Technical Service Bulletin

SUBJECT:		No: TSB-13-13-003	
KNOCK SENSOR DIAGRAM UPDATE – SERVICE MANUAL REVISION		DATE: February, 2013	
		MODEL: 2009–2010 Outlander	
CIRCULATE TO:	<input type="checkbox"/> GENERAL MANAGER	<input type="checkbox"/> PARTS MANAGER	<input checked="" type="checkbox"/> TECHNICIAN
<input checked="" type="checkbox"/> SERVICE ADVISOR	<input checked="" type="checkbox"/> SERVICE MANAGER	<input type="checkbox"/> WARRANTY PROCESSOR	<input type="checkbox"/> SALES MANAGER

This TSB updates the diagrams regarding the knock sensor's location and connector number in the service manual of affected vehicles.

SENSOR

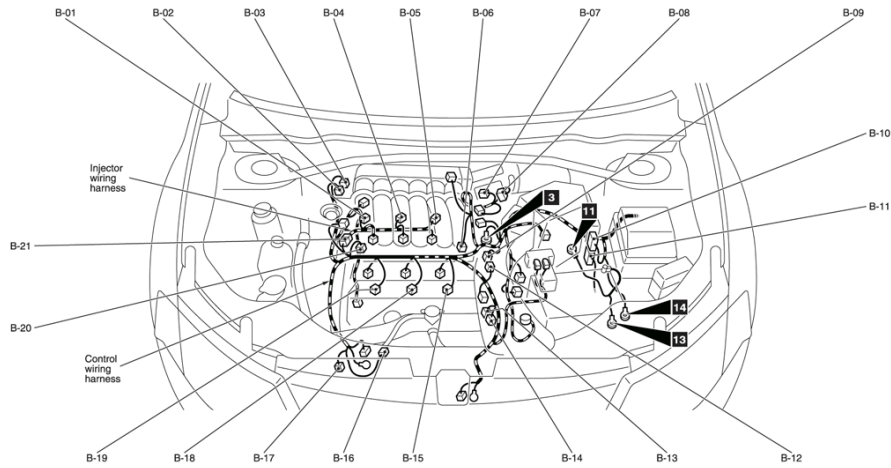
For the 2009 Outlander Service Manual Group 70: Components Location – Sensor, please update the diagram displaying the knock sensor’s location as follows:

<Correct>
Knock sensor 1

<Correct>
Knock sensor 1 connector

Knock sensor 2 connector
<Correct>

Knock sensor 2
<Correct>

ENGINE AND TRANSAXLE <3.0L ENGINE>

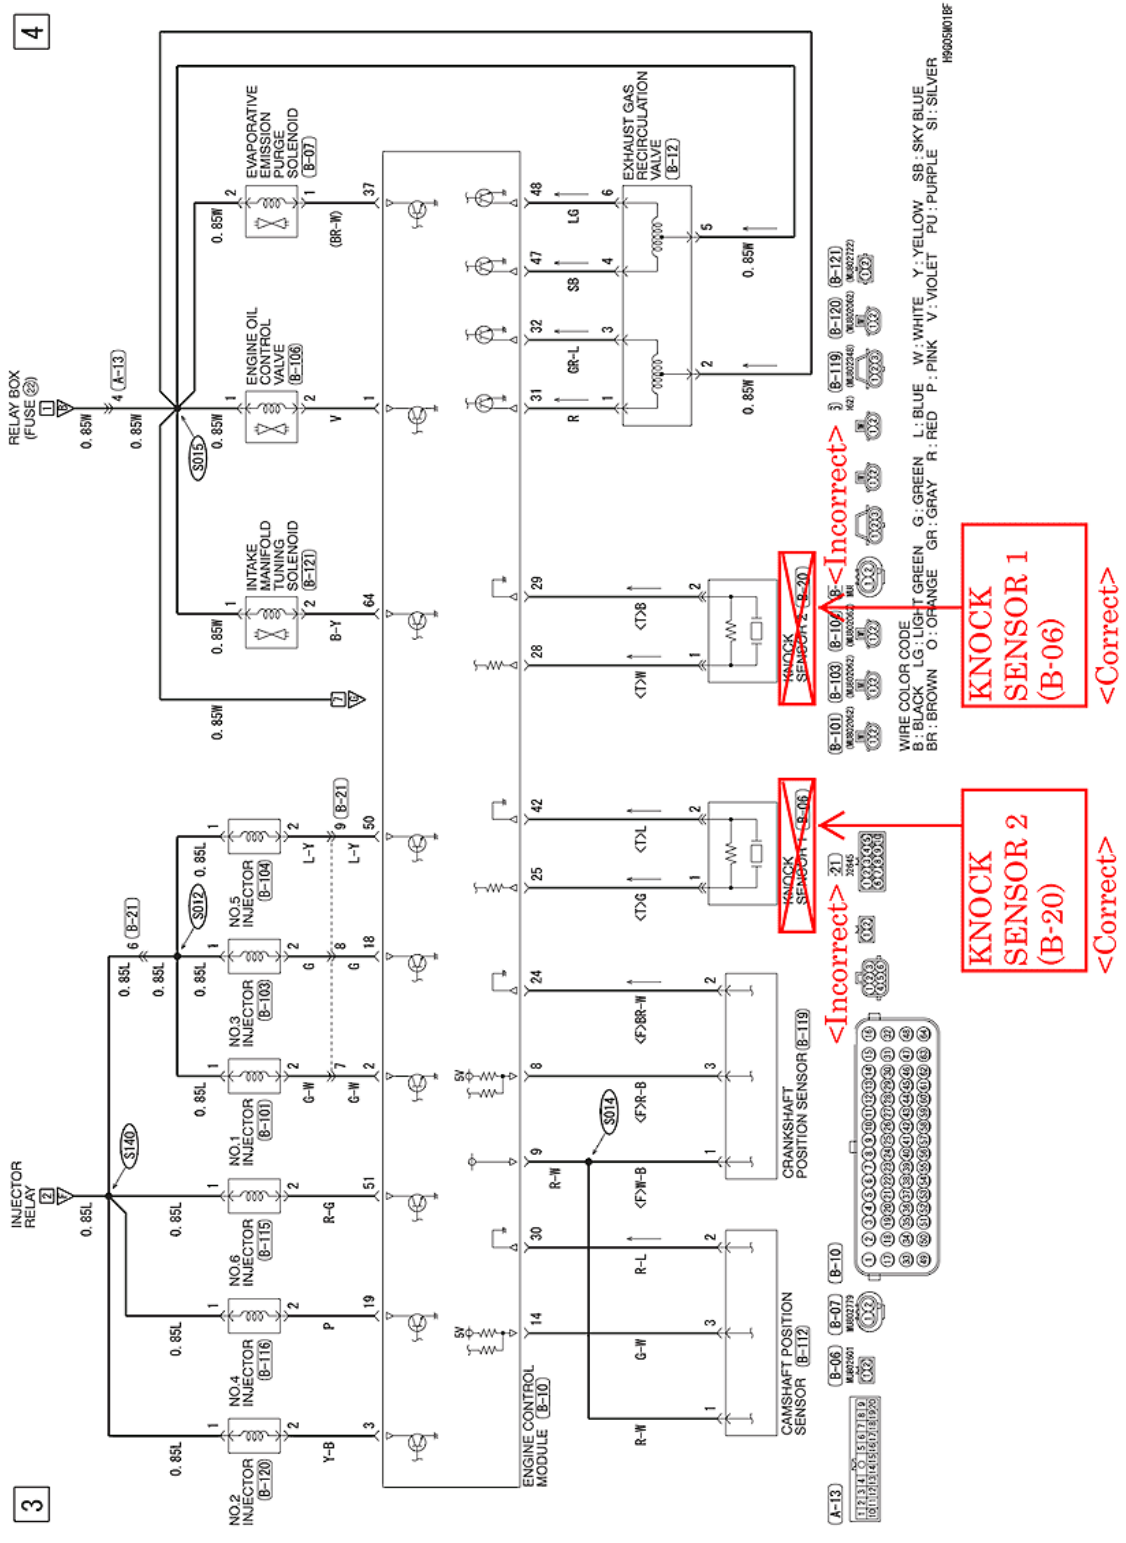
For the 2009 Outlander Service Manual Group 80: Configuration Diagrams – Engine and Transaxle <3.0L Engine>, please update the diagram displaying the knock sensor’s connector number as follows:

| B-06 (2-B) Knock sensor 2 <Incorrect> | B-17 (1-B) A/C compressor assembly |
| B-09 (2-B) Engine coolant temperature sensor | B-20 (2-B) Knock sensor 1 <Incorrect> |

Knock sensor 1
 <Correct>

Knock sensor 2
 <Correct>

MFI SYSTEM <3.0L ENGINE>

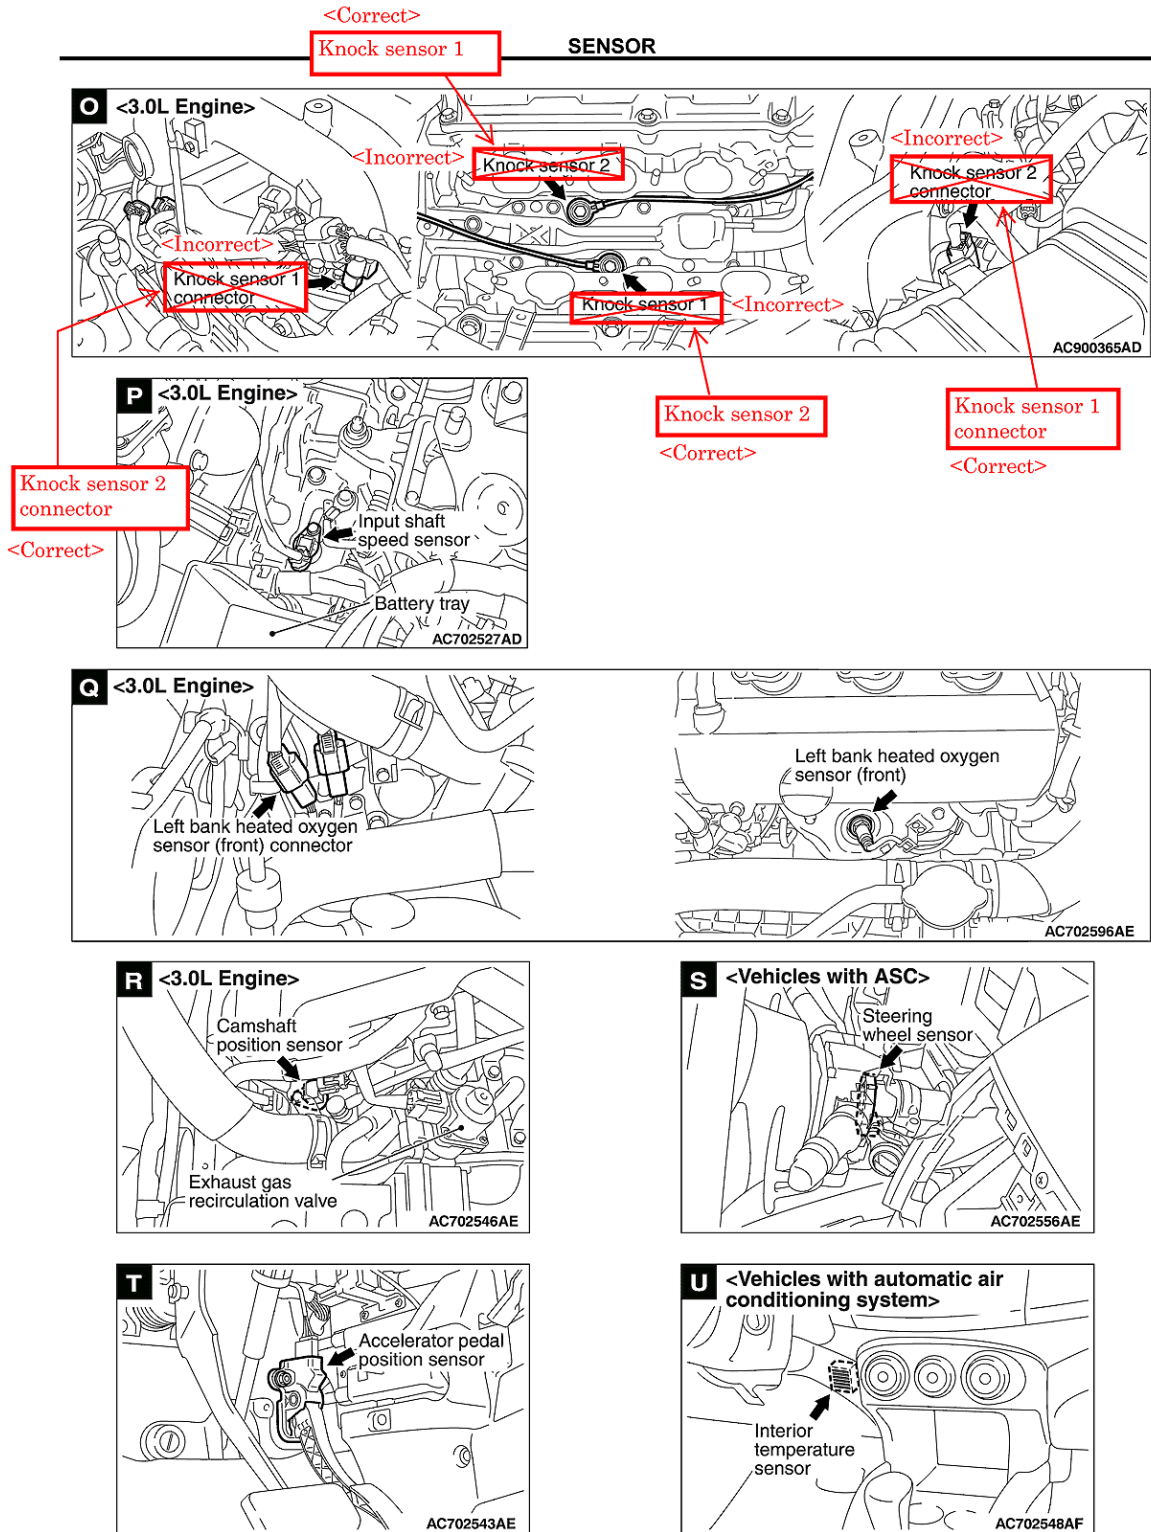
For the 2009 Outlander Service Manual Group 90: Circuit Diagrams – MFI System <3.0L Engine>, please update the diagram displaying the knock sensor’s connector number as follows:

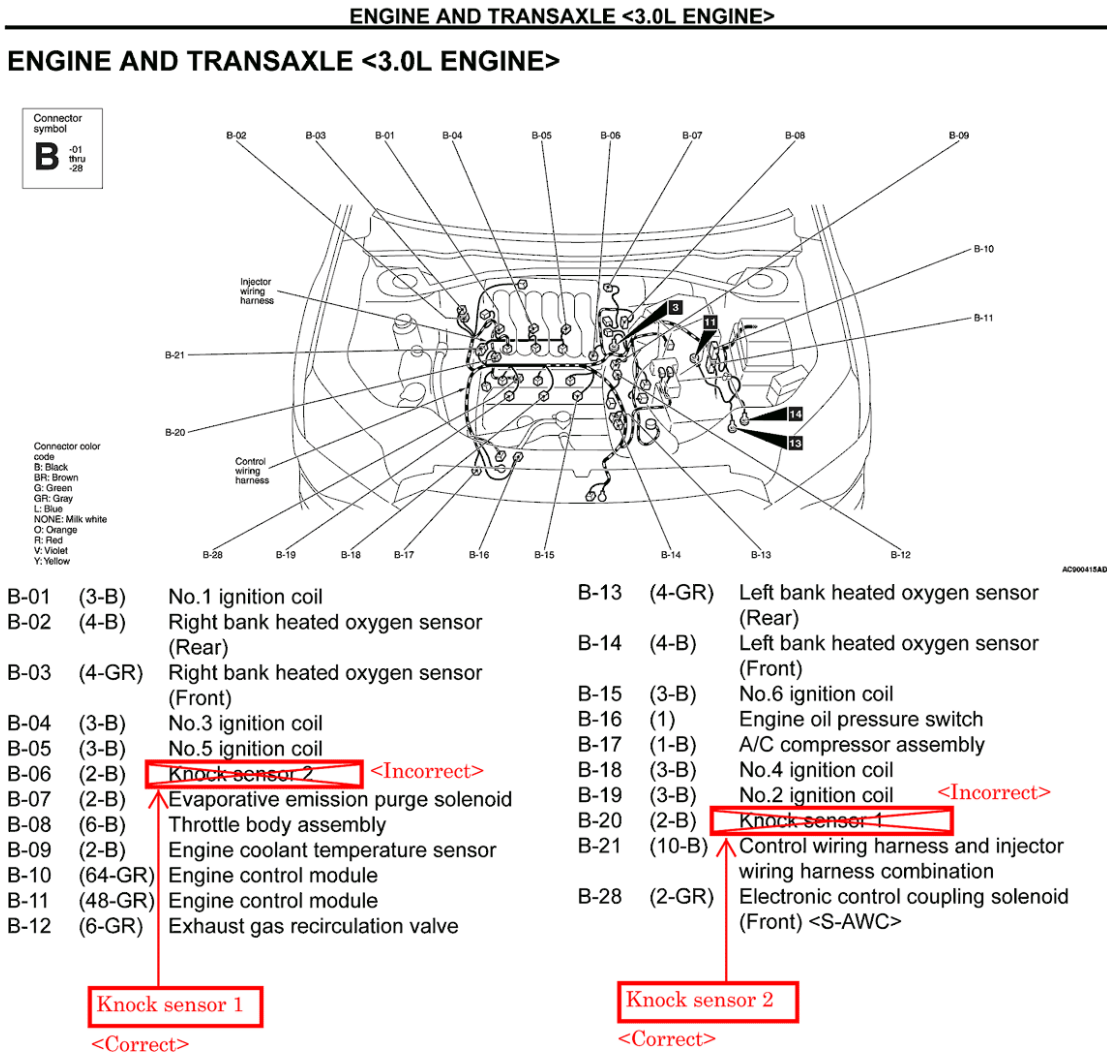
For the 2010 Outlander Service Manual Group 70: Components Location – Sensor, please update the diagram displaying the knock sensor’s location as follows:

MFI SYSTEM <3.0L ENGINE>

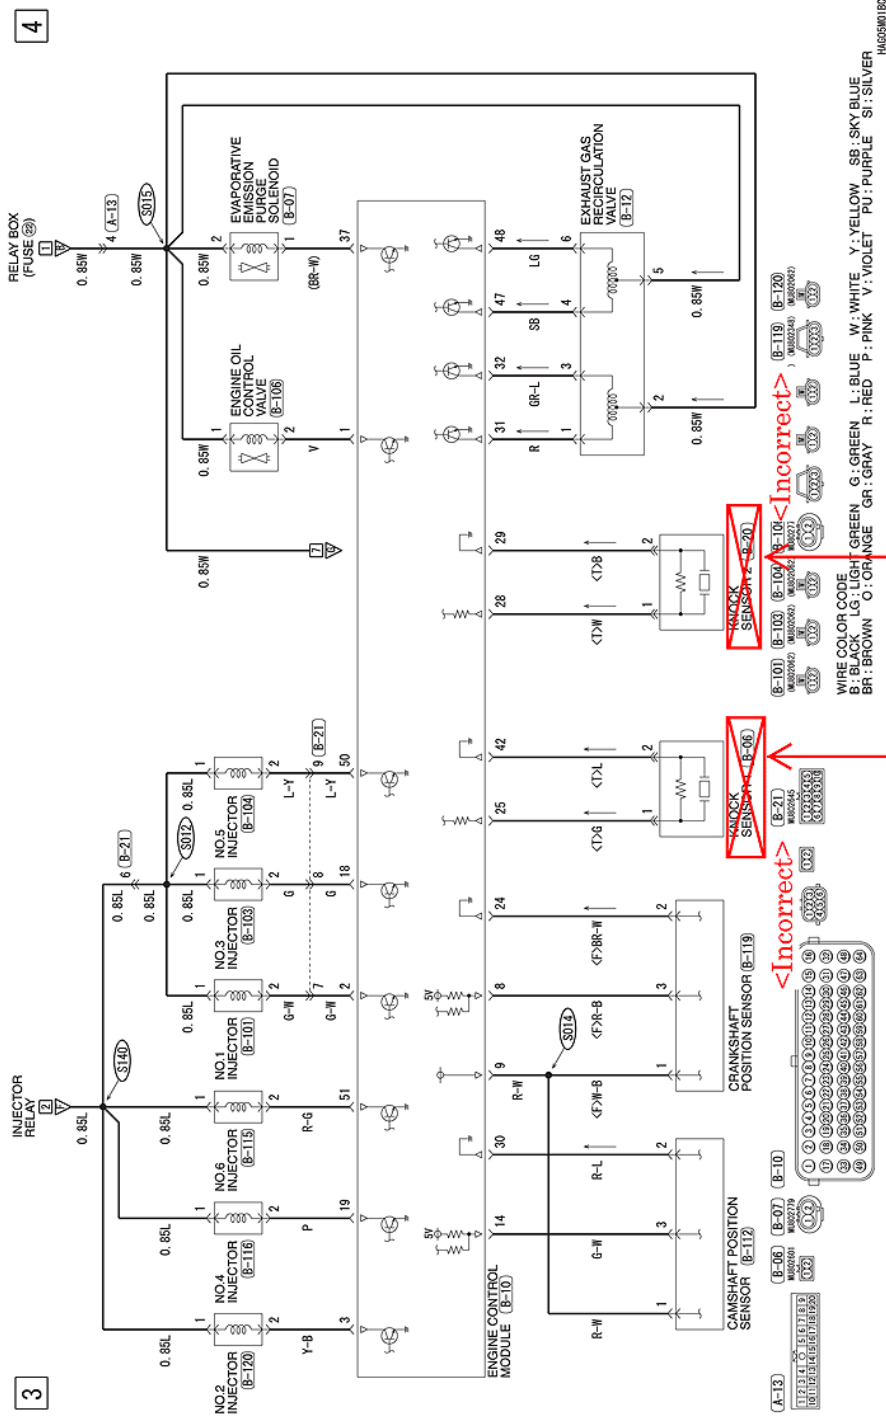
For the 2010 Outlander Service Manual Group 90: Circuit Diagrams – MFI System <3.0L Engine>, please update the diagram displaying the knock sensor's connector number as follows:
